B I D A D D E N D U M 0 6

ORANGE ULSTER BOCES

ADDITIONS & ALTERATIONS TO EMANUEL AXELROD SPECIAL EDUCATION CENTER

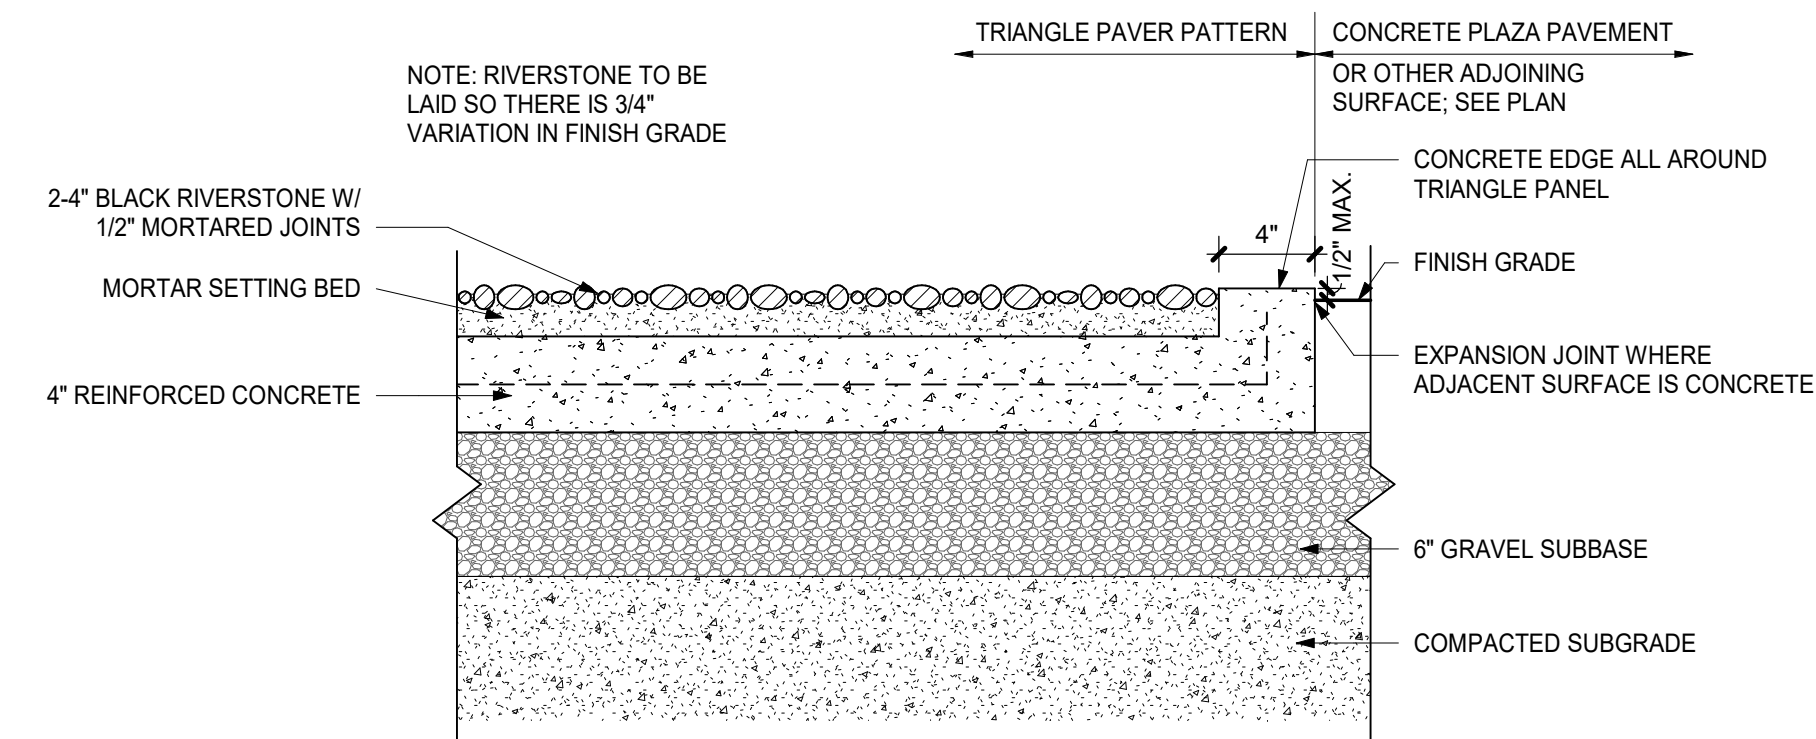
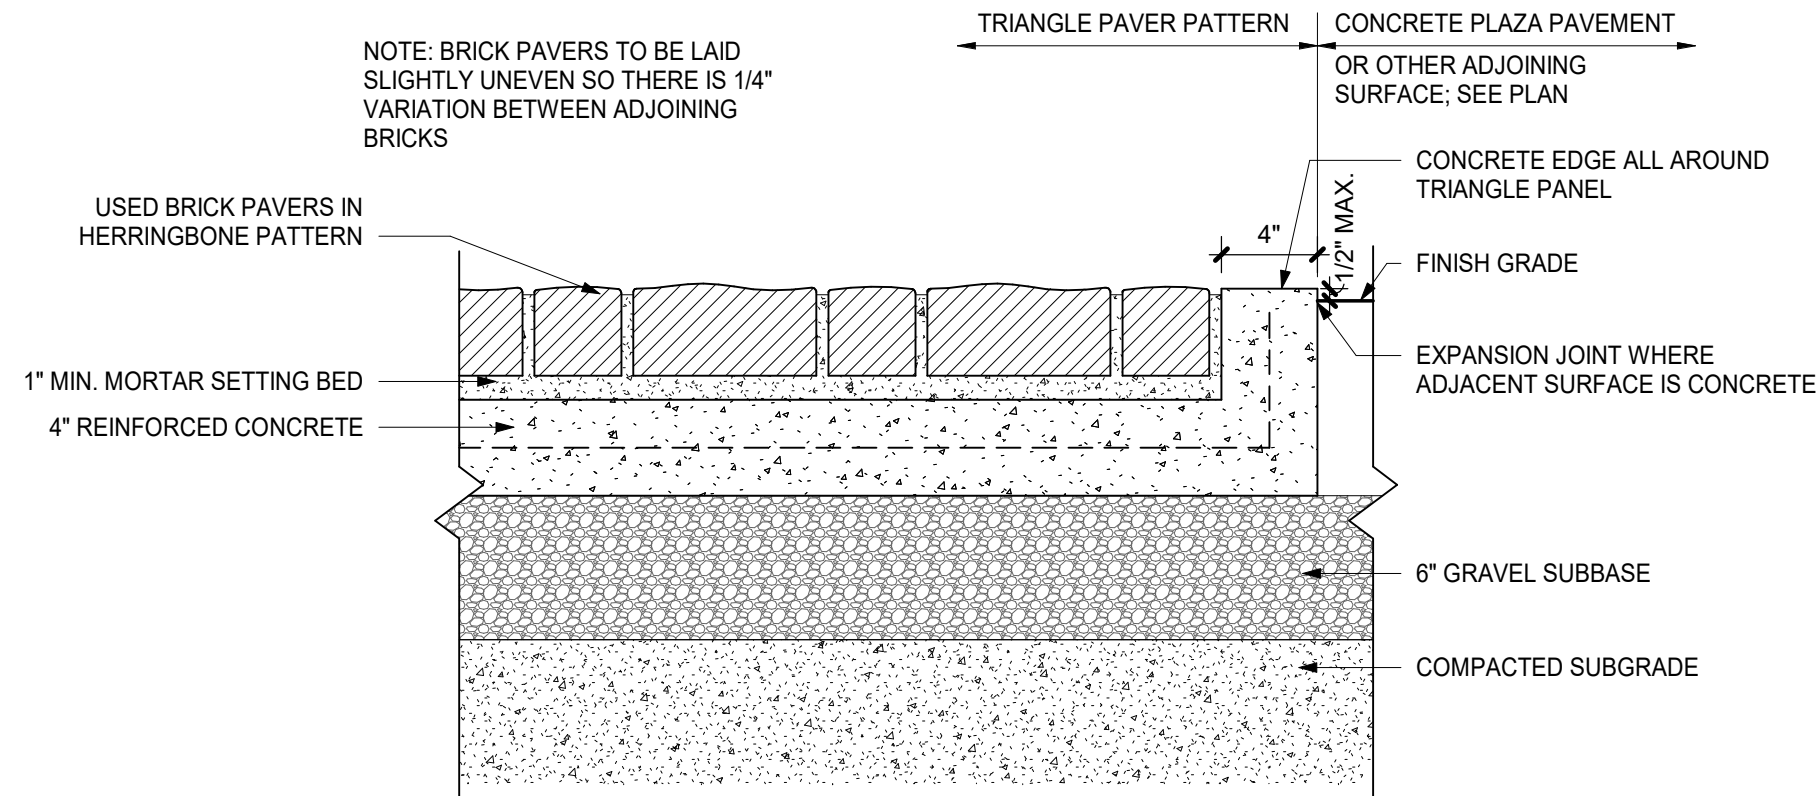
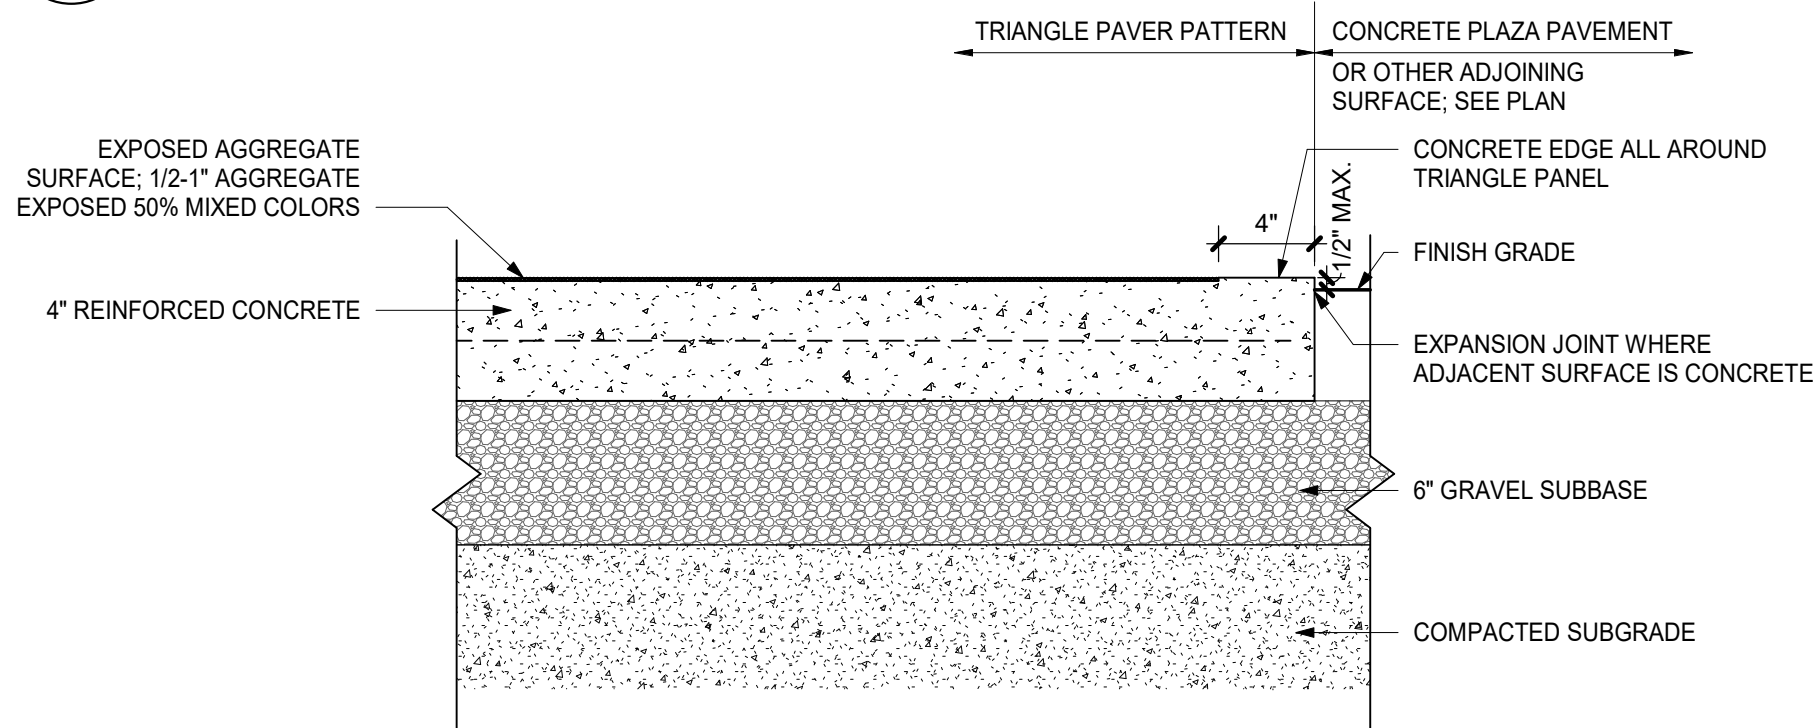
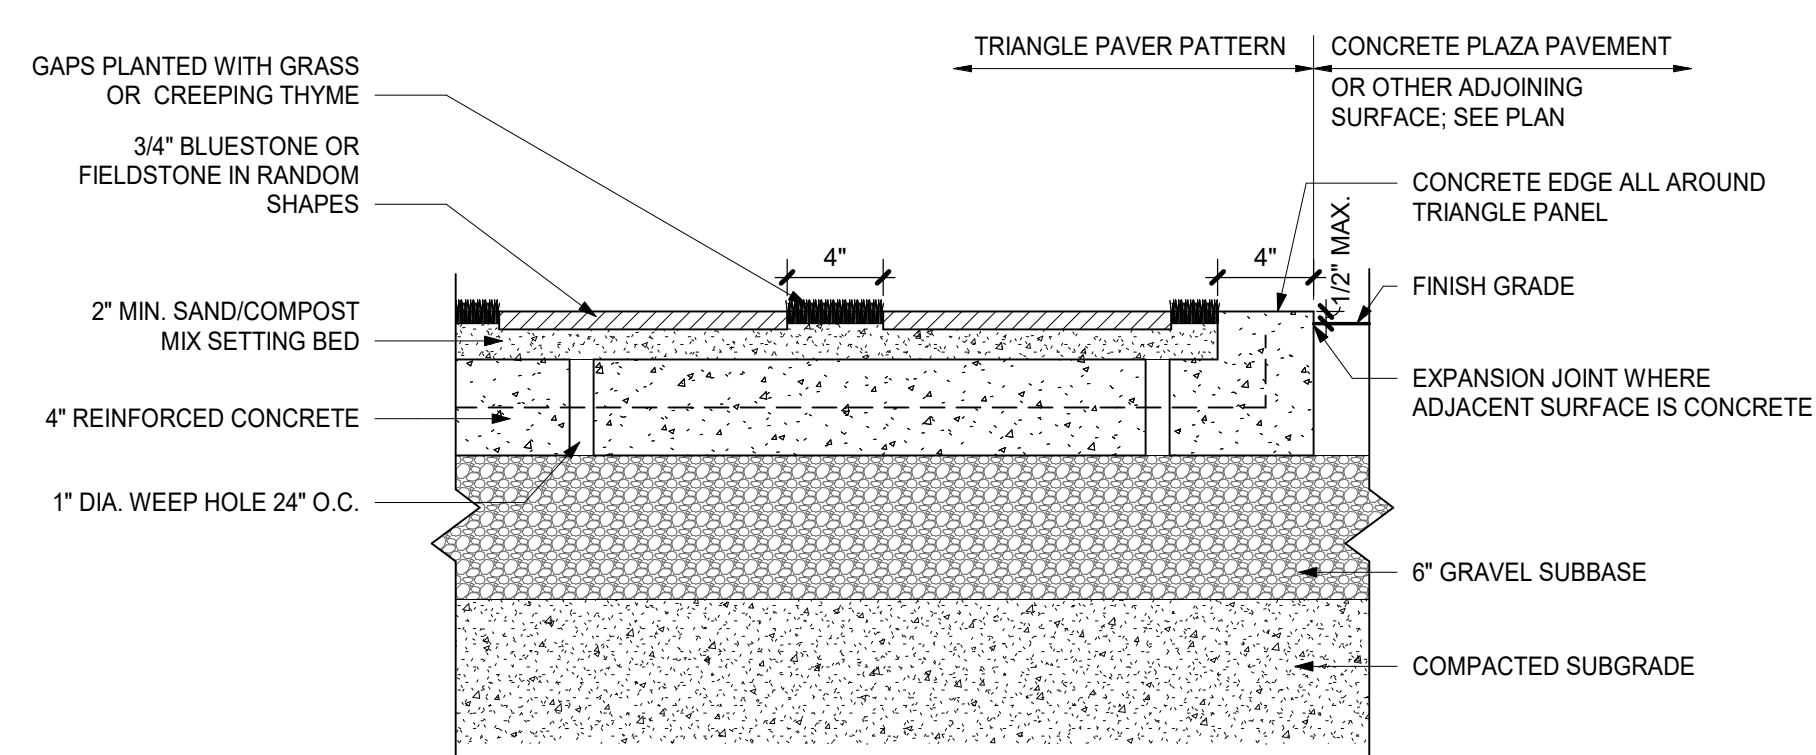
- 4.2 A102 – Ground & 2nd Floor Demo Plan
 a. See REVISED plans with note 2C removed.
- 4.3 A203 – Roof Plan
 a. See REVISED Roof Plan with new HVAC equipment shown
- 4.4 L954B – Landscape Elevations & Details – Alternate
 a. See added details regarding textured courtyard triangle pavers.

- 7.4 RFI Question – Please provide details/information of textured plaza panels
RFI Response – See REVISED L954B for details of textured plaza panels.
- 7.5 RFI Question – Where are projectors and projector screens located?
RFI Response – Disregard notes pertaining to projects and projector screens.
